Power Section

Battery Charging Section

Controller Section

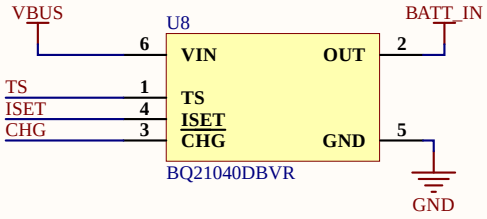
Place Decoupling Capacitor with there respective pins.

ISET Resistor Value is changed in Parameters, please be careful.

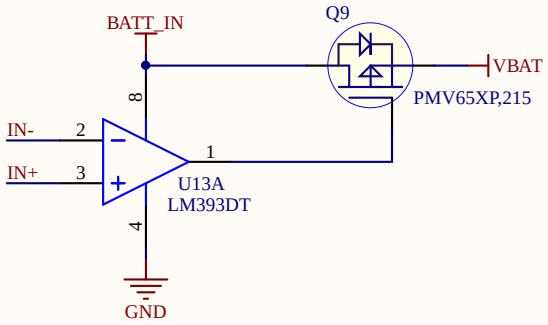
As per Datasheet, the value should not exceed 675 Ohm.

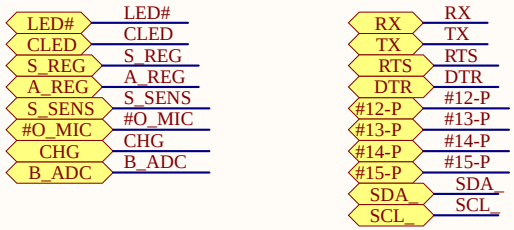
External Enable wouldn't be used as Development board already had circuit.

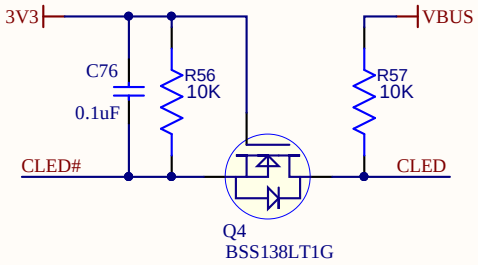
SW2 is being used for Software Reset.

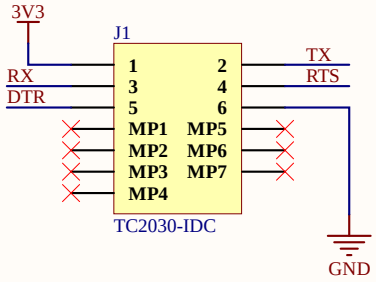
Mentioned Capacitors will be placed with Battery Connector and with USB Main Connector.

No Need to place Decoupling Capacitors with Switch as this is just path.
